Re: Certification Submittal for Final Building Certificate of Occupancy for
NMEAF Office Building, [D-17 / D86]
7400 Tiburon Street
Architect's Stamp Dated 05/06/04

Re: Architect's Certification for Permanent C.O.
NMEAF Office Building
7400 Tiburon Street NE
Albuquerque, NM 87109
Case No. 1000633

NMEAF Office Building
New Mexico Educational Assistance Foundation
7400 Tiburon Street NE Albuquerque, NM 87109
DRB Submittal Set

**RE: NMEAF Grading and Drainage Plan (D-17/D86)
Engineer's Stamp Dated June 30, 2003**

Site Plan
SCALE: 1" = 20'

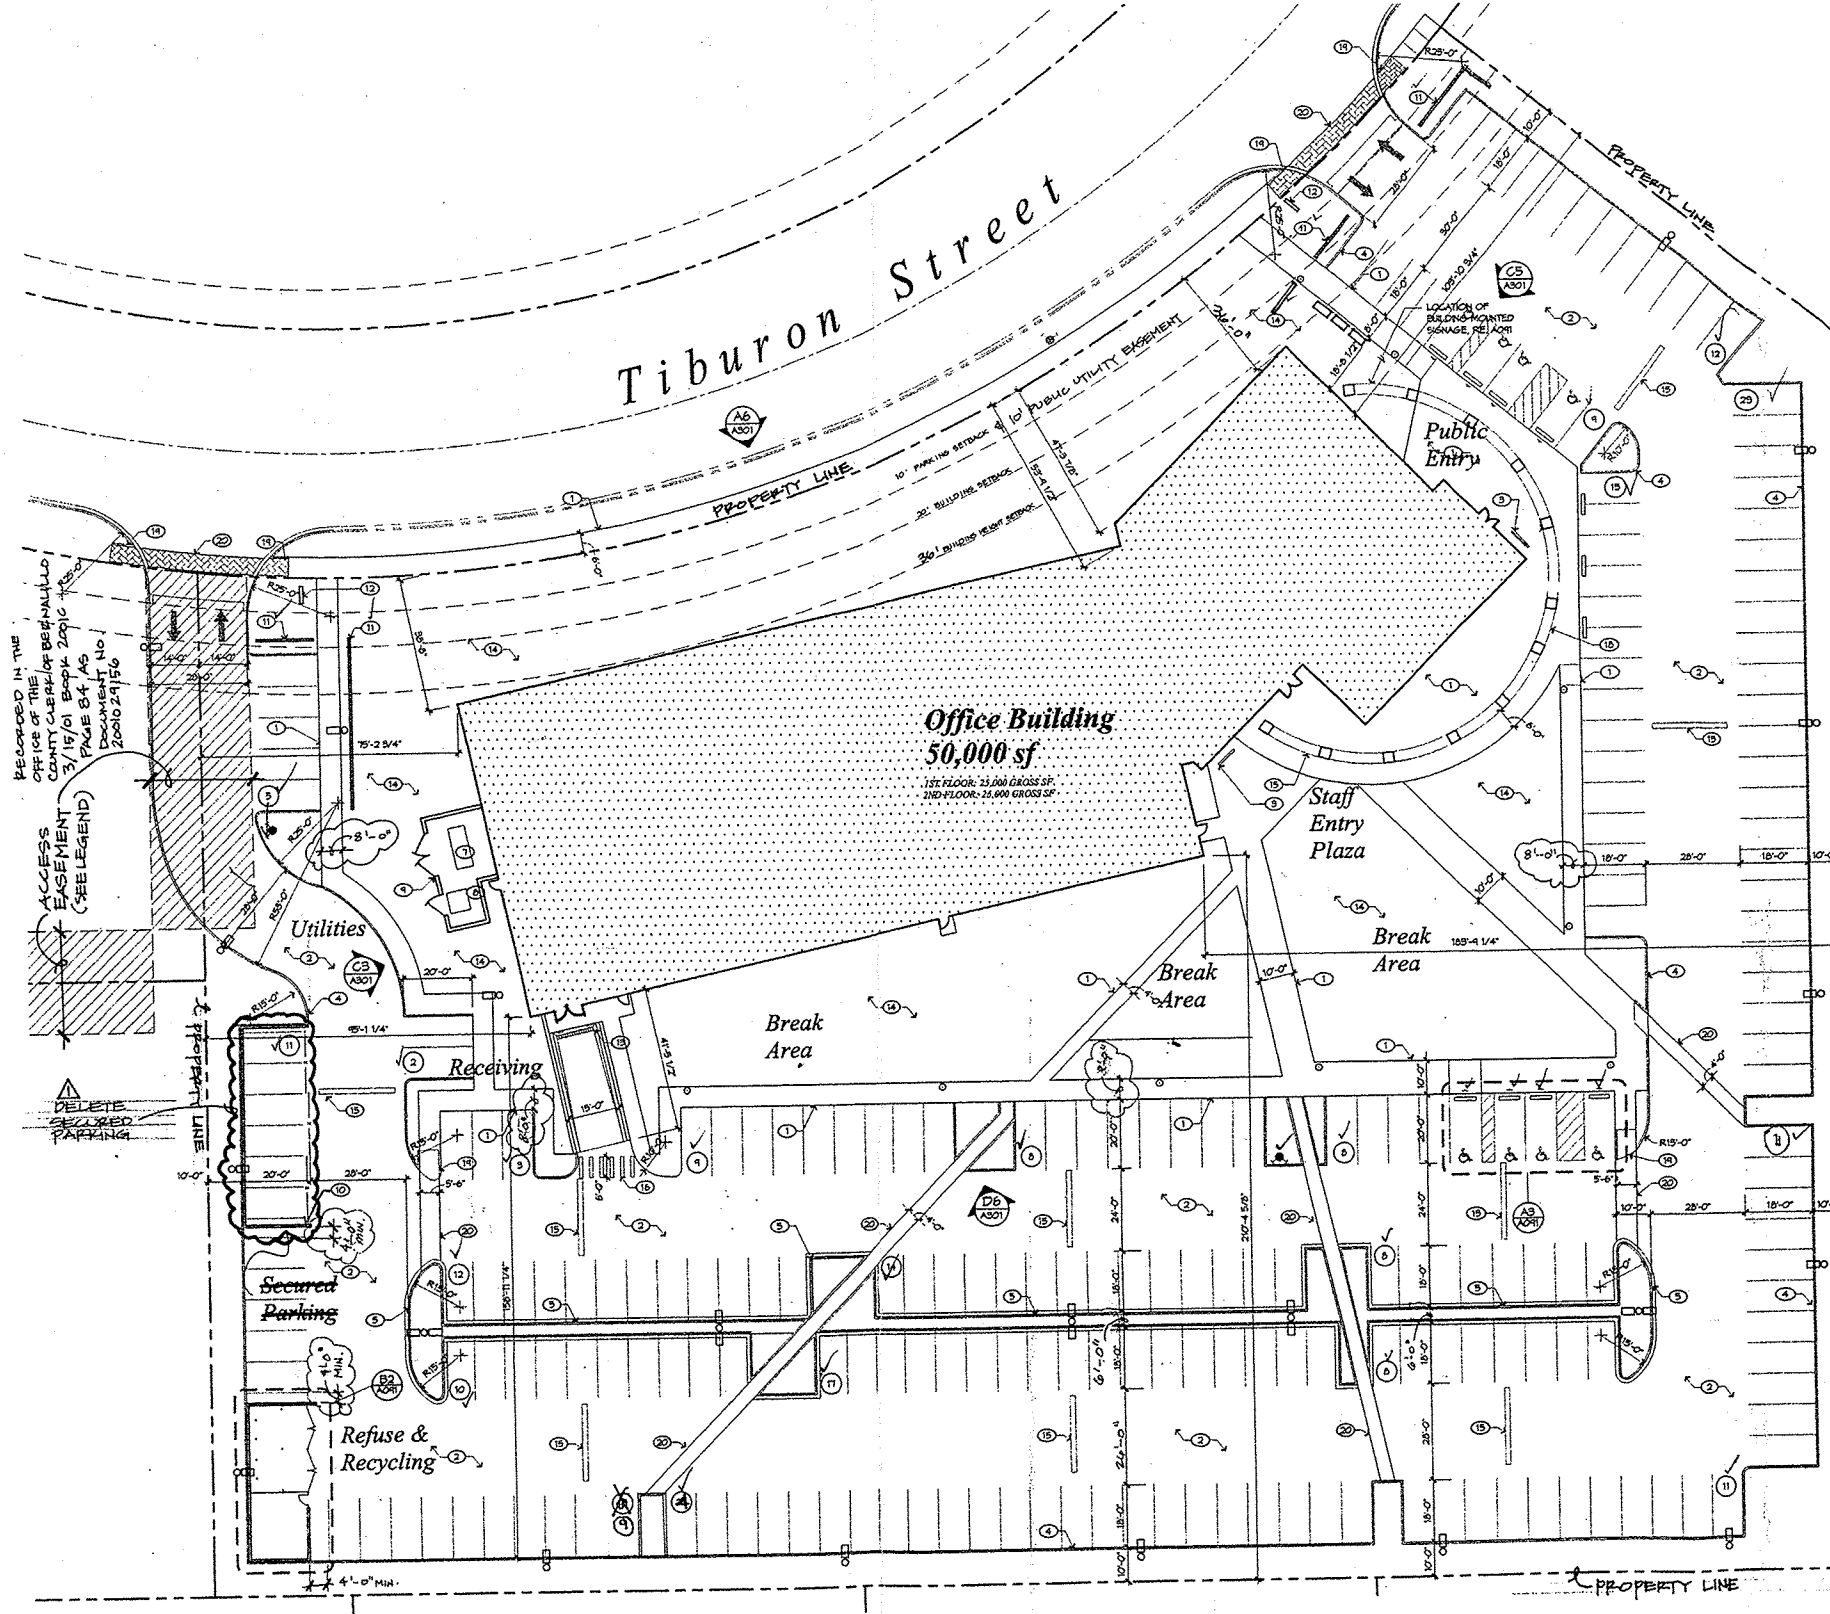
Based on our observations we hereby certify that this site has been constructed in substantial compliance with the approved Site Development Plan for Building Permit.

The TCL / Letter of Certification submitted on May 7, 2004 is sufficient for acceptance by this office for final Certificate of Occupancy (C.O.). Notification has been made to the Building and Safety Section.
